**Site Formation and Infrastructure Works
for Public Housing Development near Tan Kwai Tsuen,
Yuen Long – Investigation, Design and Construction**

**FINAL AIR VENTILATION
ASSESSMENT REPORT -
EXPERT EVALUATION**

199086/BIN/104/Issue 3
July 2023

Appendix 1	Cross Sections of Proposed Scheme
Appendix 2	Response to Comments Records

Drawing No. Figure 1.2

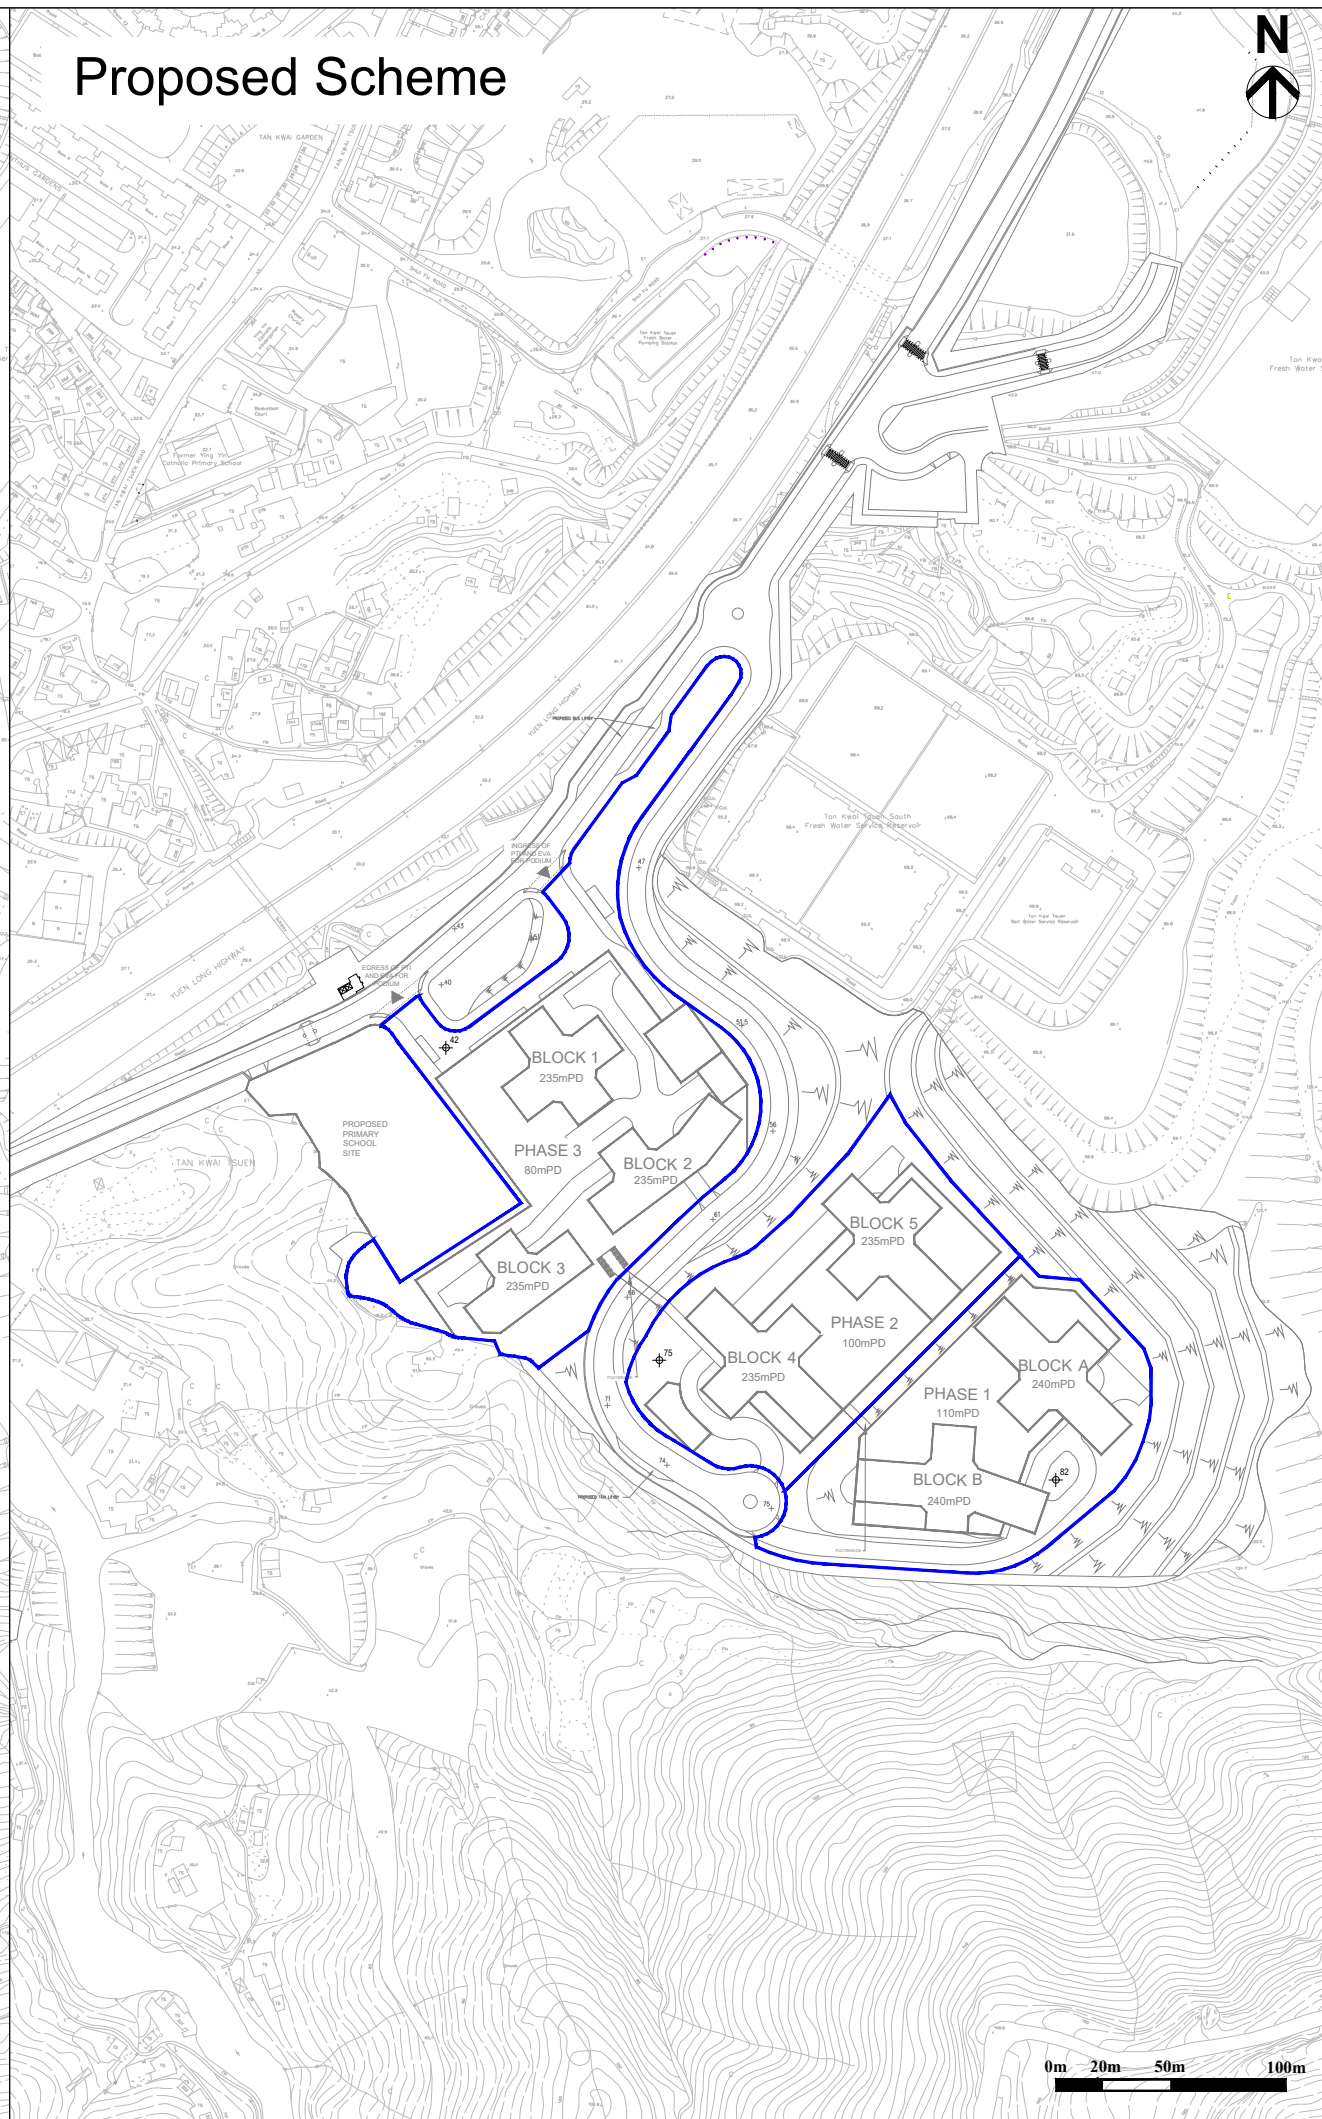
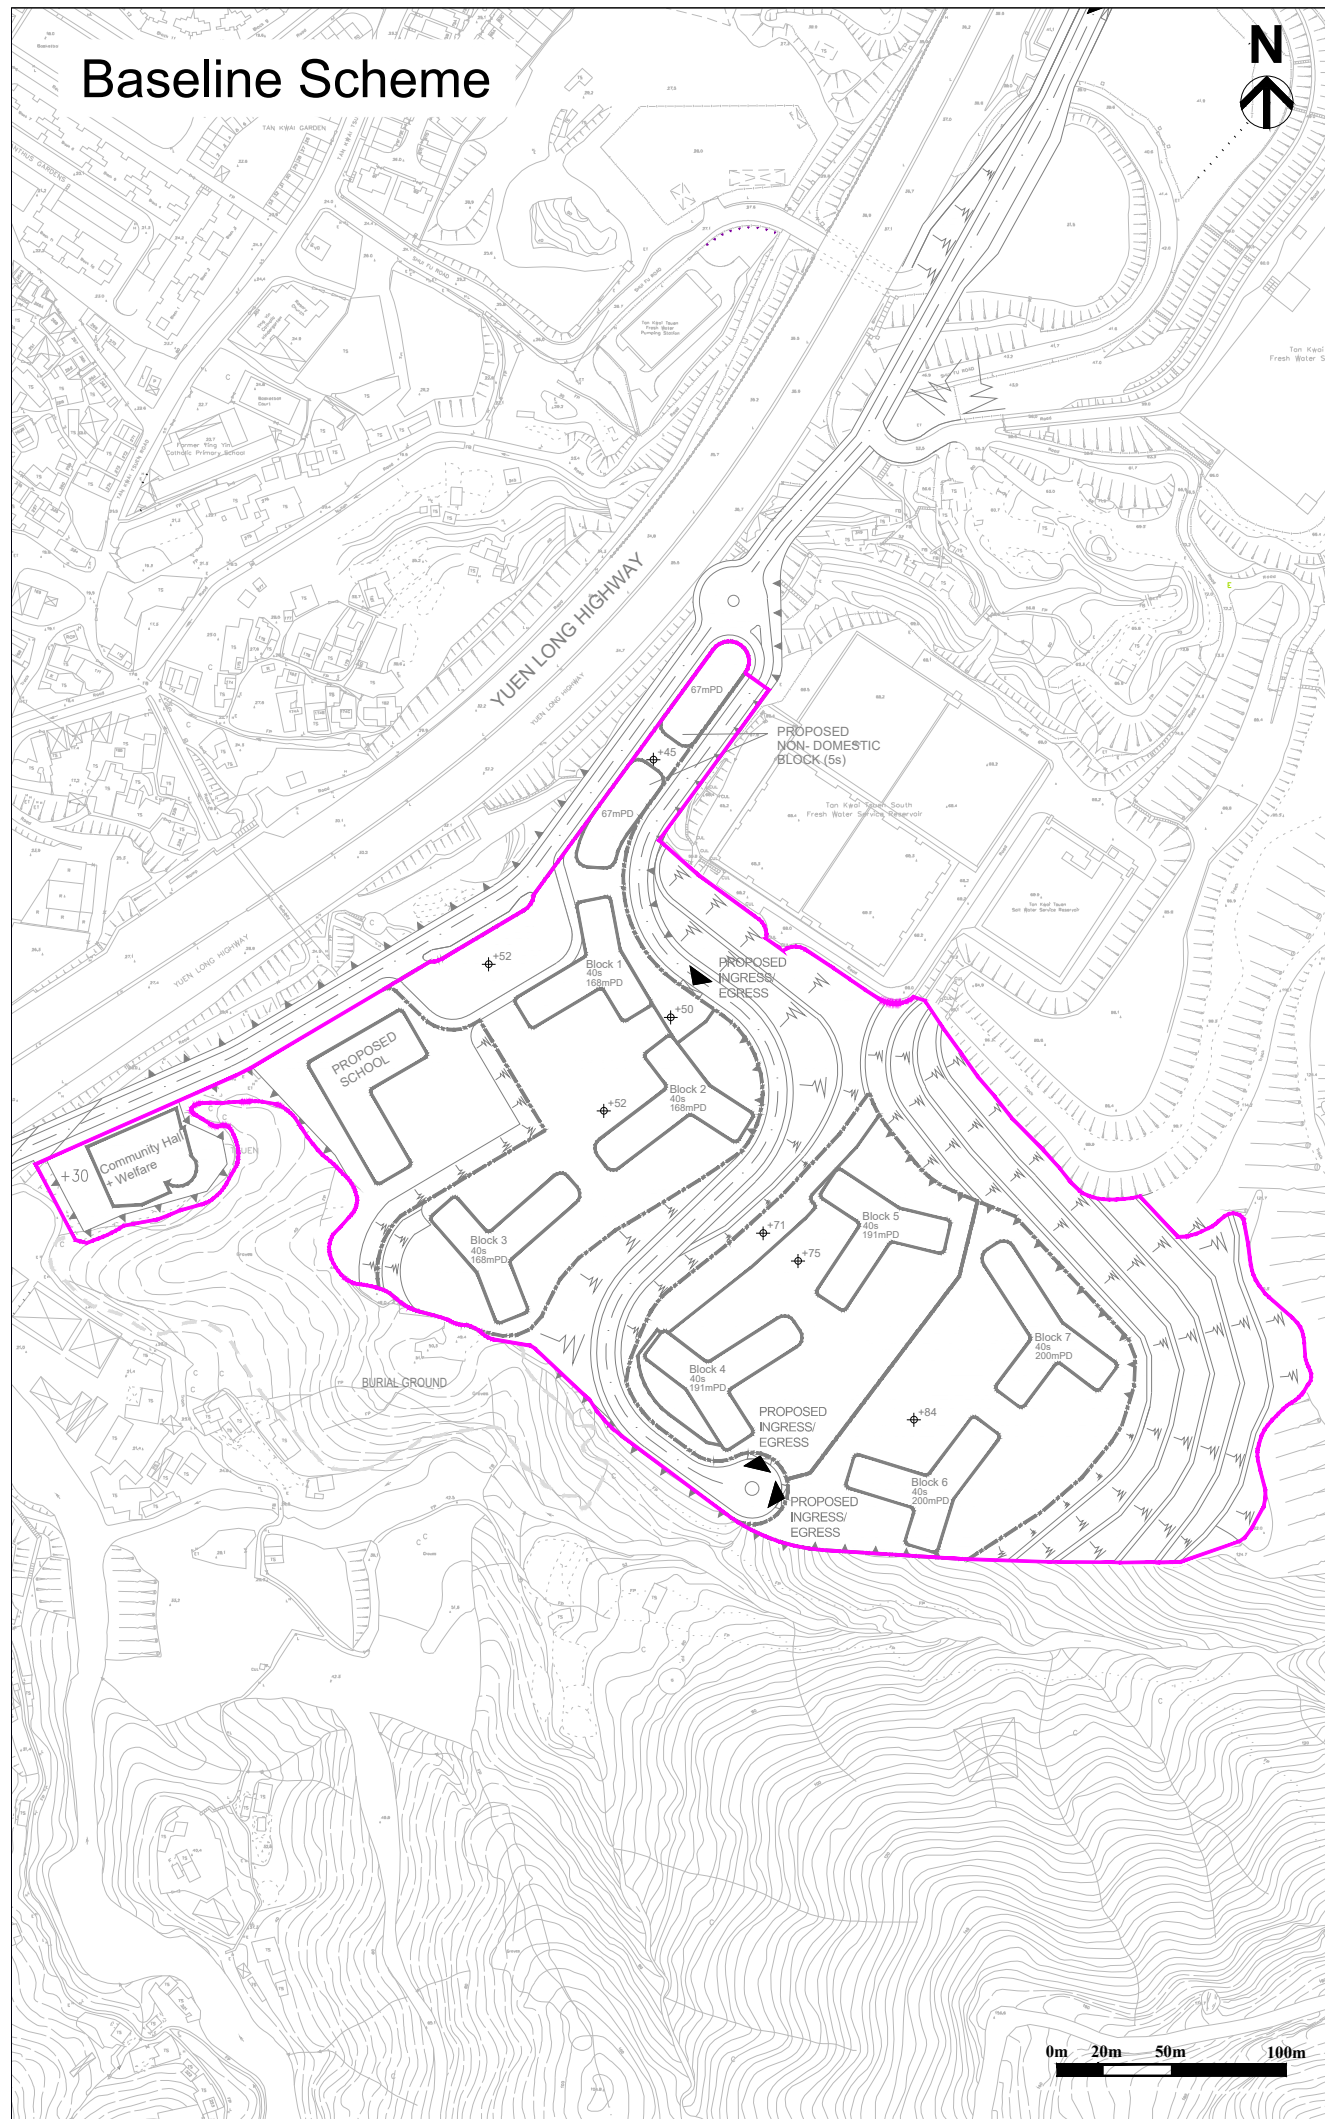
Comments	Responses
<p>about 80mPD to 110mPD (Paras. 1.4.2 & 1.5.2 and Figure 1.2 refer) under the proposed scheme. The Consultant should provide discussions on such differences between the baseline scheme and proposed scheme, and assess their potential impacts on the surrounding pedestrian wind environment as appropriate.</p>	
<p>25) Besides, there seems no discussion on the proposed footbridges nor information on their heights (in mPD) and design (e.g. whether permeable design is to be adopted) in Figure 1.2.</p>	<p>Please note that the design information of the proposed footbridge is not available at this early stage and the wind hinderance effect of the proposed footbridges is anticipated to be minor because the size of footbridge is expected to be small.</p> <p>Sections 1.5.2 has been revised.</p>
<p>26) In view of the above comments, please review and revise Sections 3 and 4 and relevant figures, as appropriate.</p>	<p>Noted. Sections 3 and 4 and relevant figures are amended.</p>

Drawing No. Figure 2.1

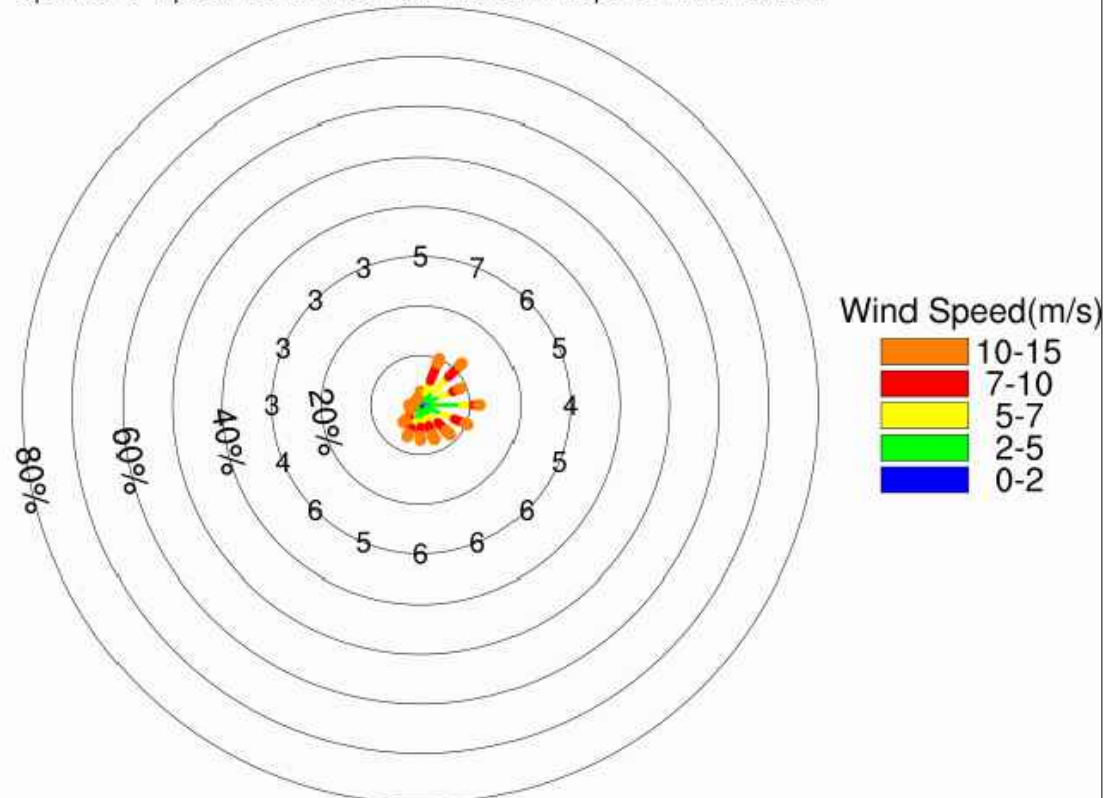
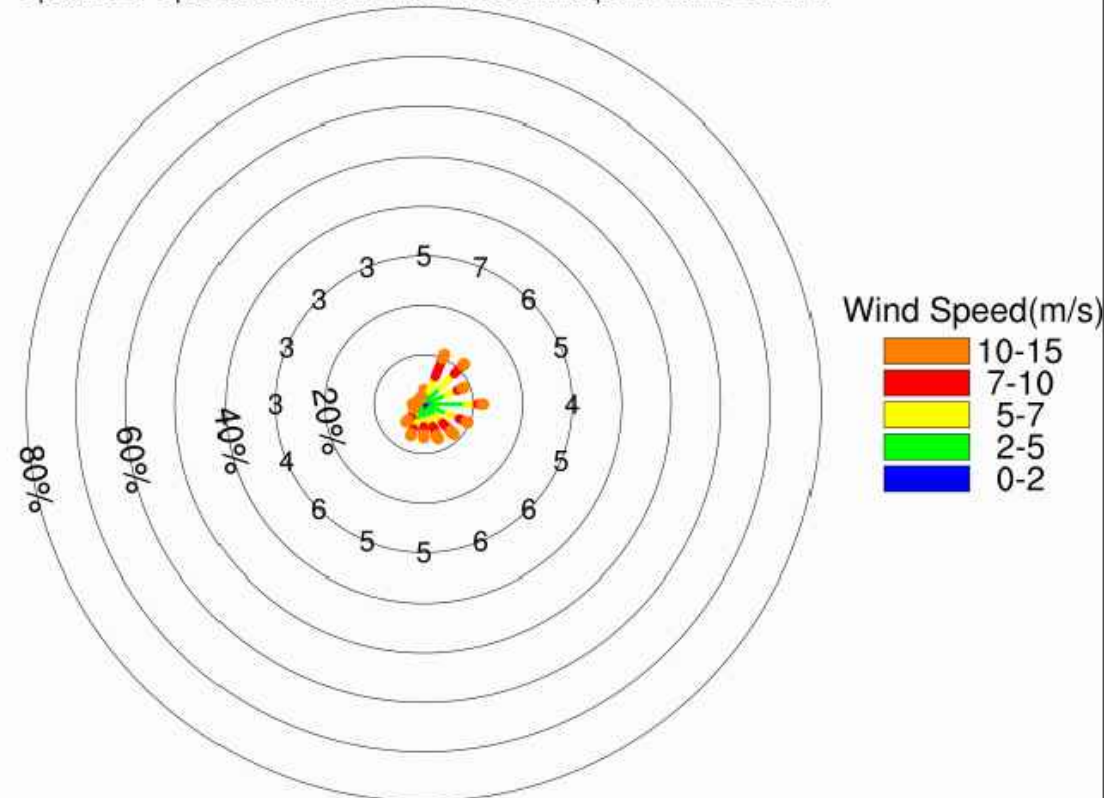
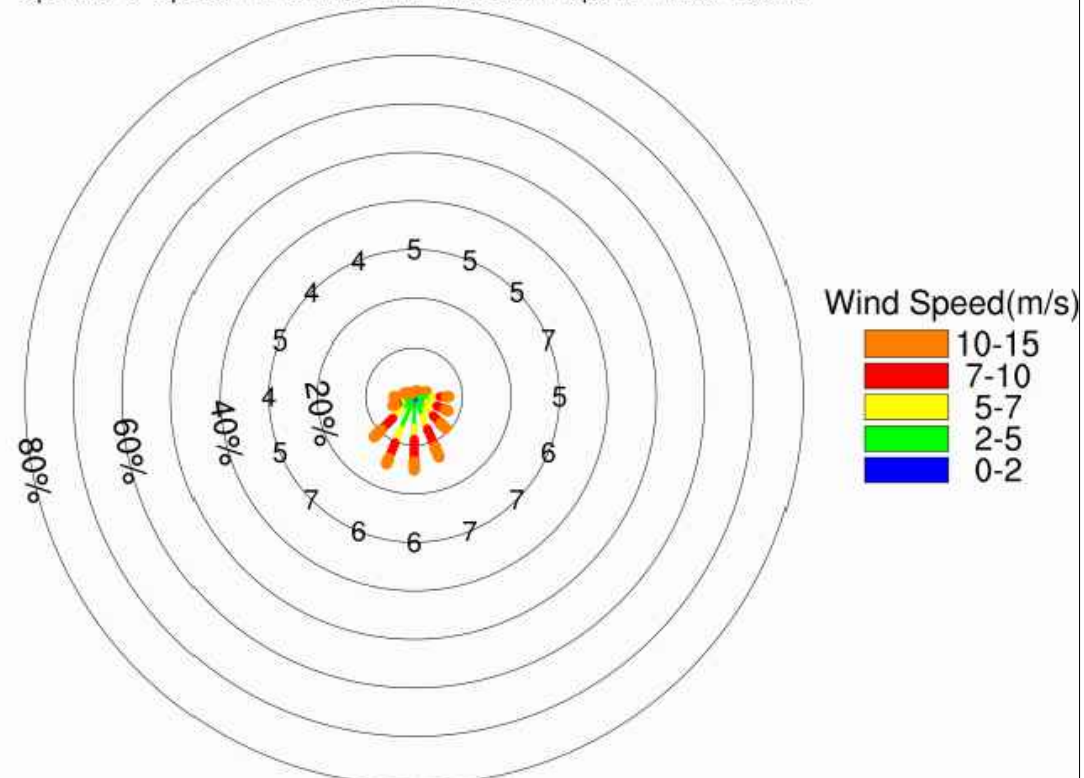
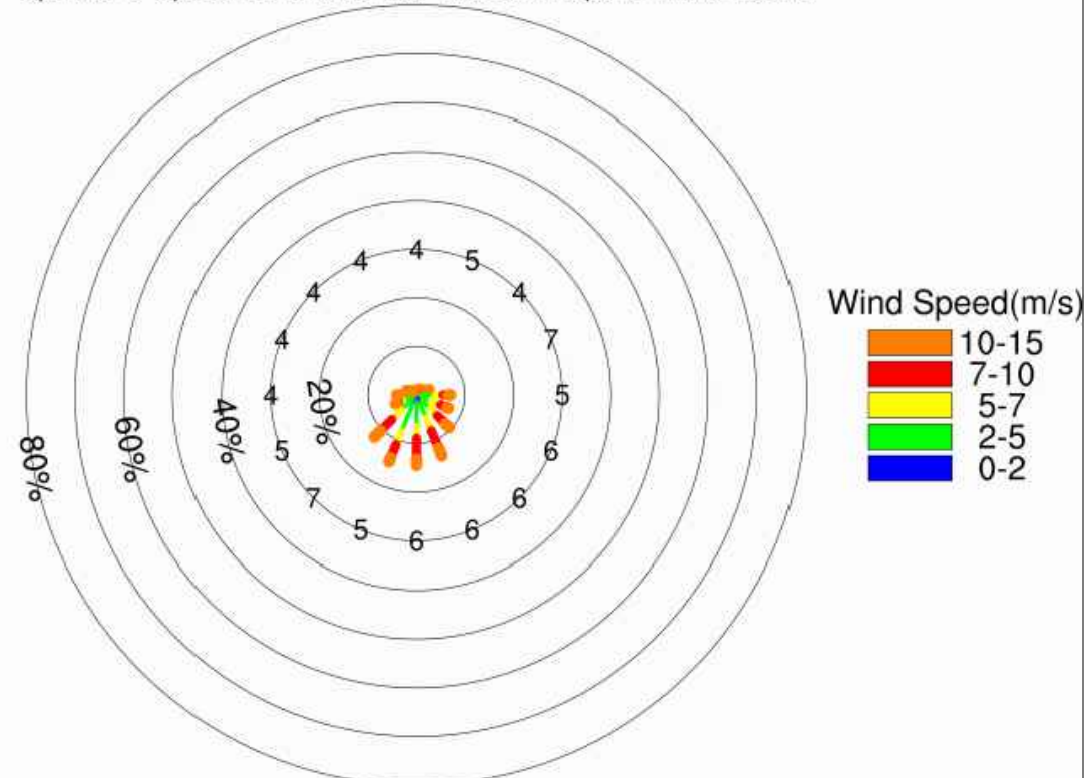
Comments	Responses
Air Ventilation Assessment	
22) Section 2.1 Site Wind Availability Data – With reference to the RAMS data from the Site Wind Availability Data of Planning Department’s website, the Site mainly falls within both grids (044, 066) and (044, 065). However, only RAMS data of grid (044, 066) is presented in Section 2.1. Please consider adding discussion on RAMS data of grid (044, 065) in this section. In particular, it is suggested that ESE shall also be identified as one the major annual prevailing wind directions. Please review and rectify the relevant assessments, as appropriate.	Noted. RAMS data of grids (044,065) and (044,066) are considered in the revised report and ESE is identified as one of the major annual prevailing wind directions which is included in the discussion of Sections 2, 3 and 4. Figure 2.1 and Table 2.1 under Section 2.1 have also been revised accordingly.
